STAFF REPORT

ITEM: Wyndham Village Preliminary Plat and Zoning Map Amendment

Re: Wyndham Village Preliminary Plan Review

Job No. 2016-70
SHEET 1 OF 2

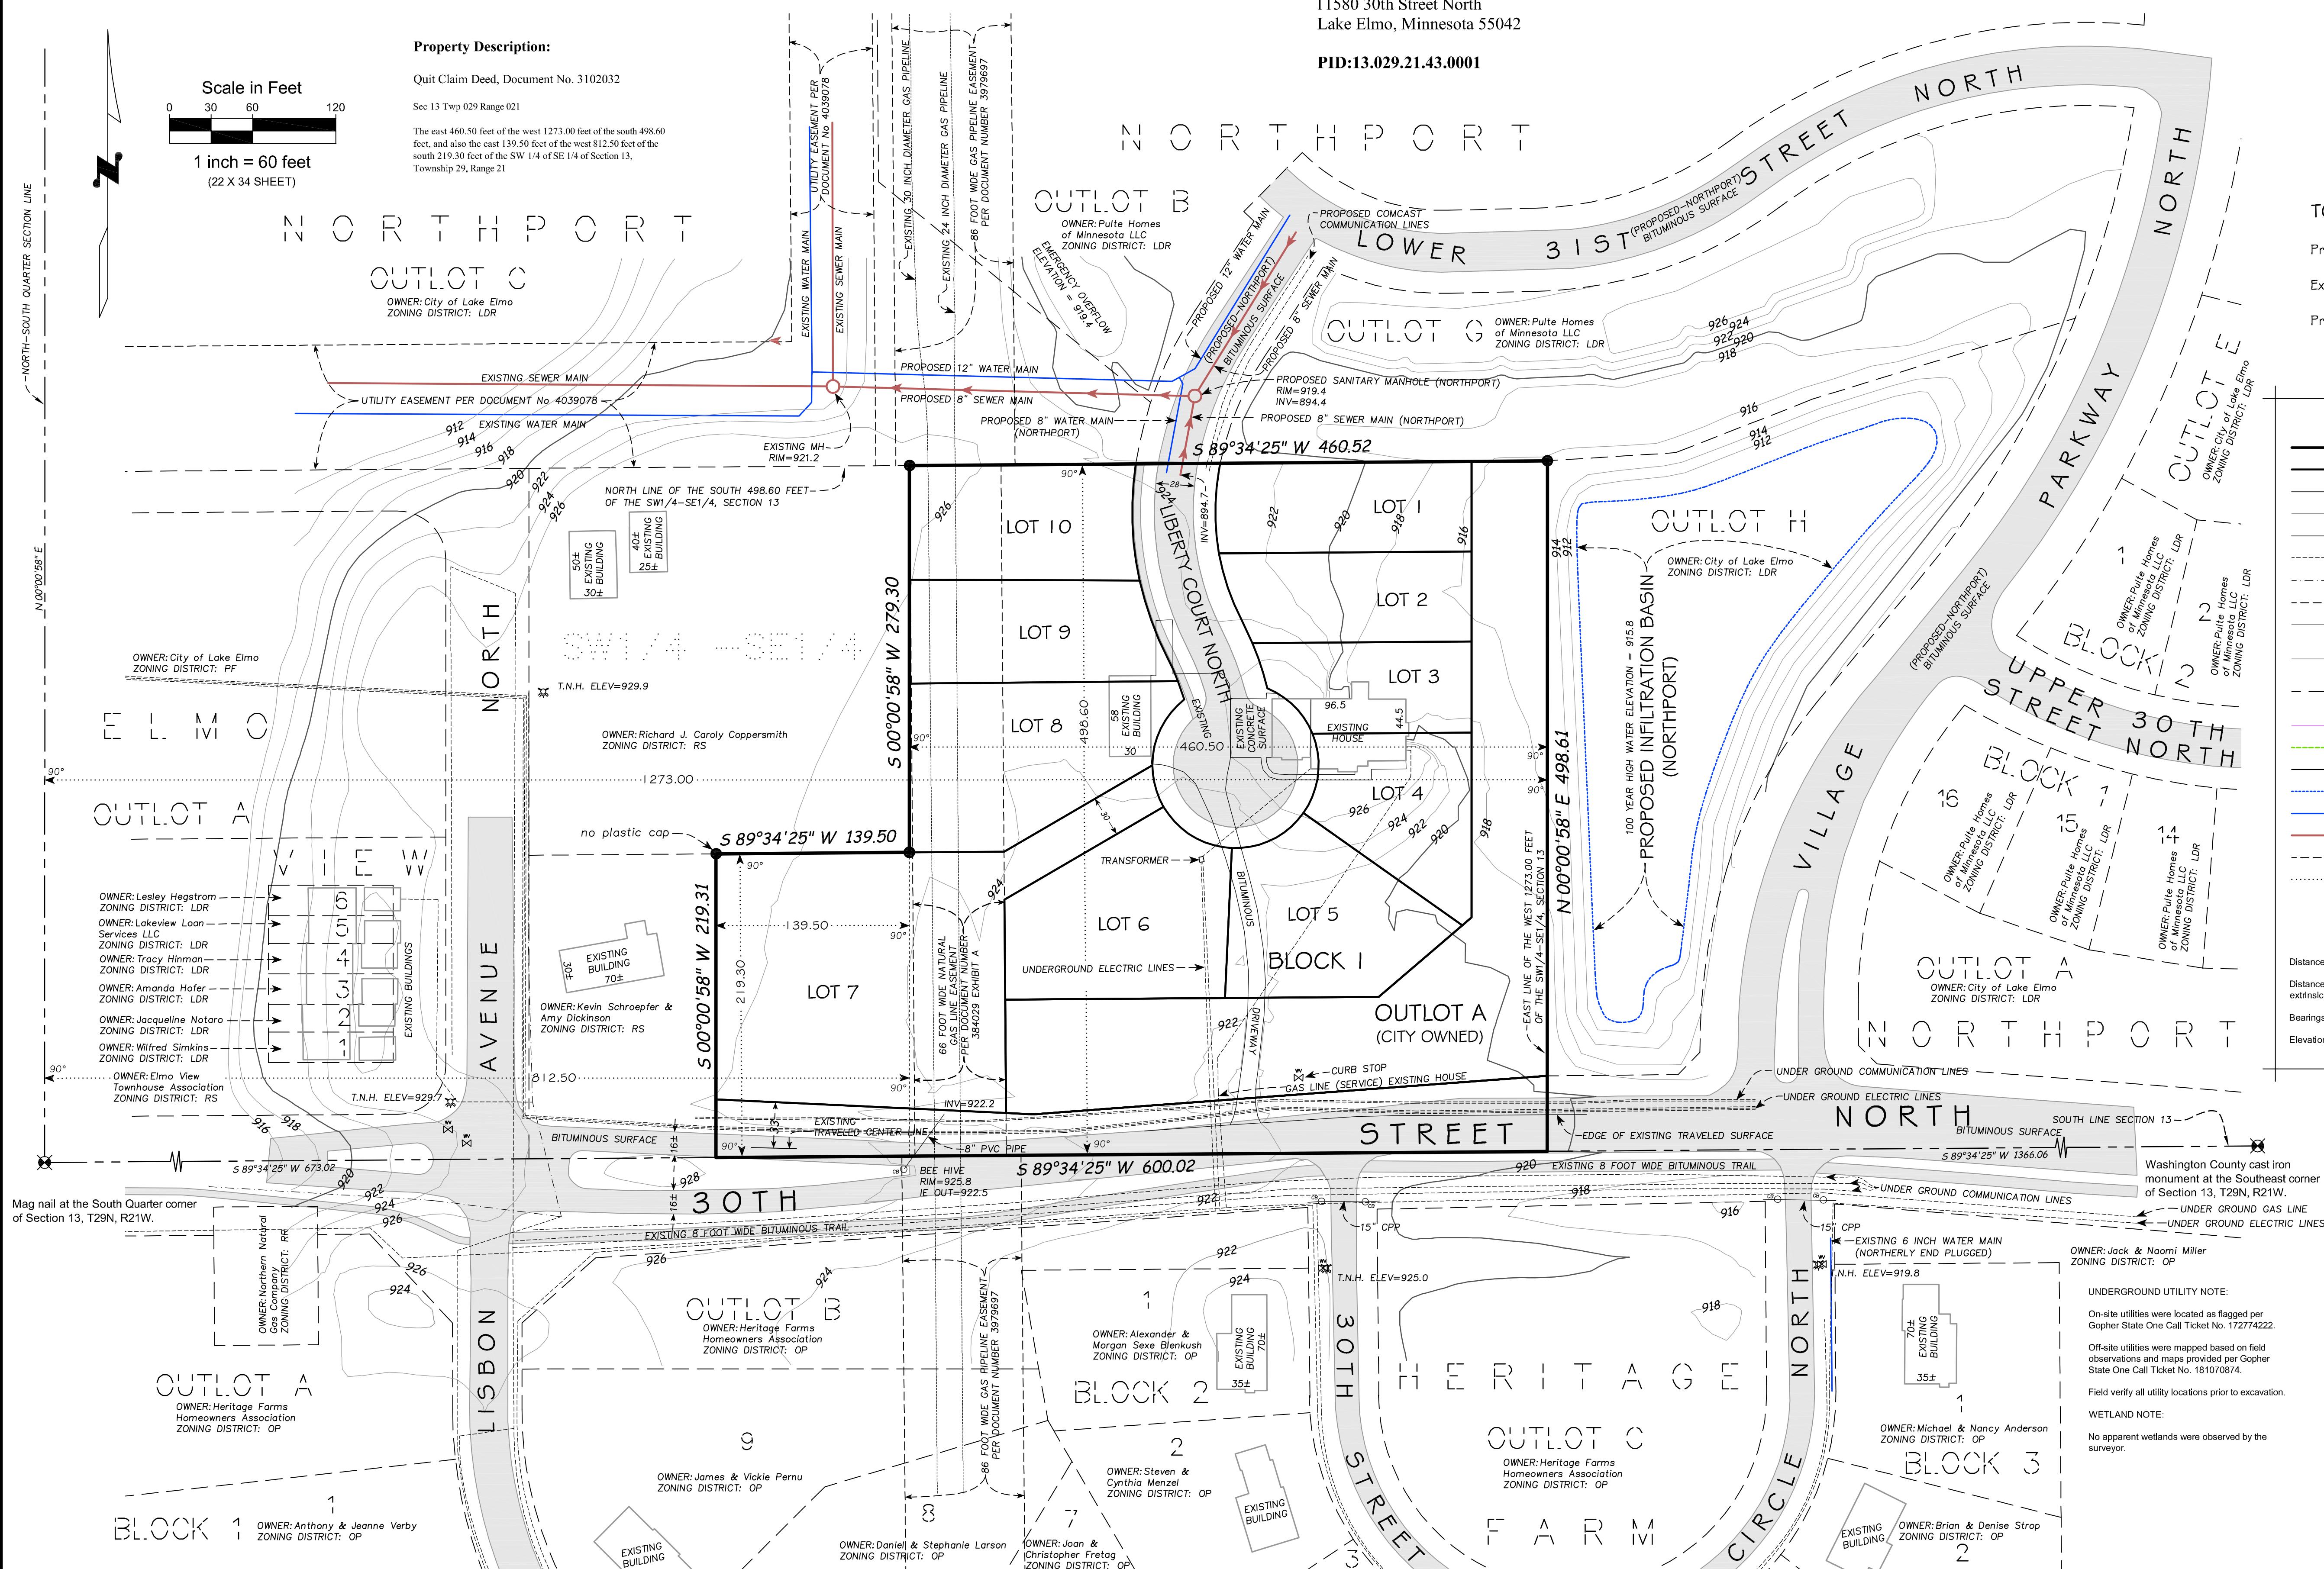
- Right-of-way/Easement Dedication. The Preliminary Plat and all preliminary plan sheets must be revised to dedicate additional right-of-way along 30th Street North to ensure a minimum 30th Street boulevard of 16 ft. along the entire length of the plat. The current plans show a varied boulevard width from 11-25 feet. In addition, a 10 ft. utility corridor must be reserved (at boulevard grades) for small utilities. The proposed storm water facilities (including the 100-year HWL) must be revised further north to prevent encroachment onto the 10 ft. utility corridor.

- Outlot A must be dedicated to the City for storm water maintenance. Outlot A has been shown as City-owned on the preliminary plat and plans as required. Outlot A may need to be revised to accommodate additional right-of-way along 30th Street and/or to expand the storm water 100-year HWL flood area.

- Drainage and utility easements are required over all storm sewer, sanitary sewer and watermain not located on City Outlots and right-of-way, minimum 30-feet in width centered on the pipe/structure. Easements must be shown on the Preliminary Plat, Utility Plans and Grading Plans.

- Per City requirements all storm sewer pipe easements must be a minimum 30-feet in width. Additional easement is required over Lots 5 and 6 to provide a minimum 30-ft easement centered over the pipe.

PRELIMINARY TREE INVENTORY PLAN:

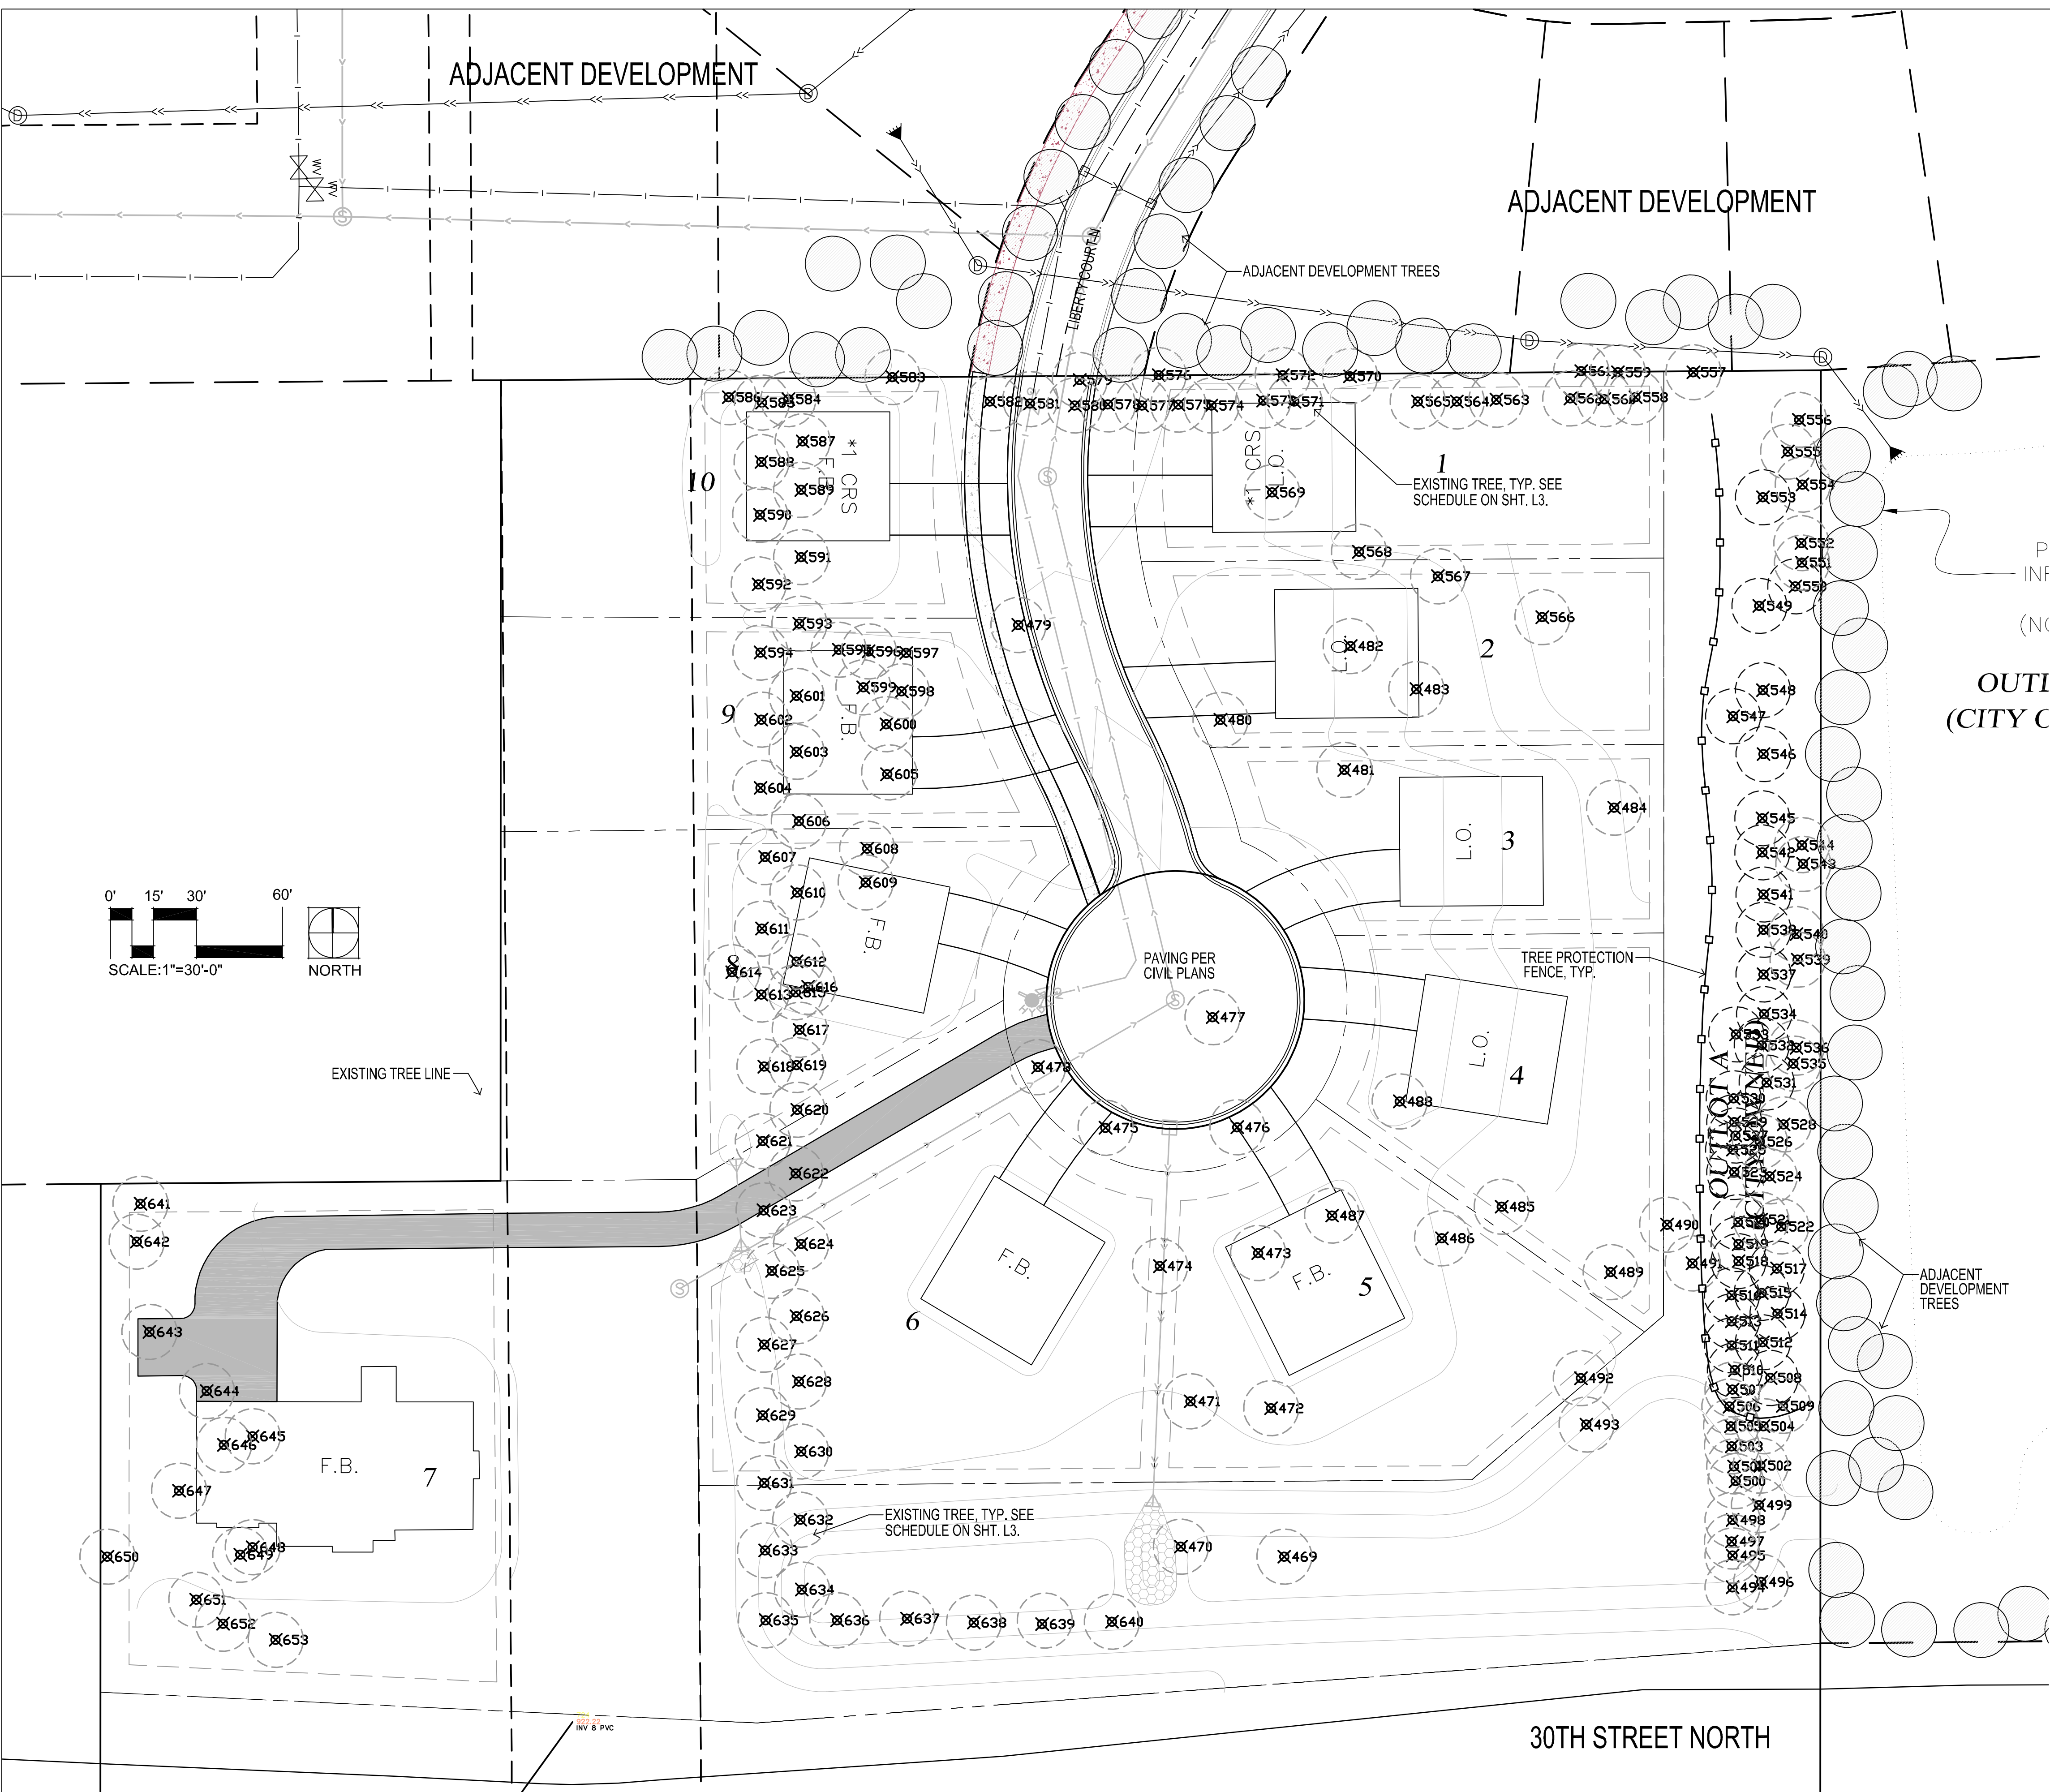
- This review does not cover the Landscape Plan or Irrigation Plan. Plan review to be completed by other City representatives.
- The Landscape Plans must be revised to accommodate maintenance access to all storm water BMPs. Grades along pond access cannot exceed 10% and must be a minimum of 20 feet in width. Maintenance access from public right-of-ways must be shown on the Landscape Plans.
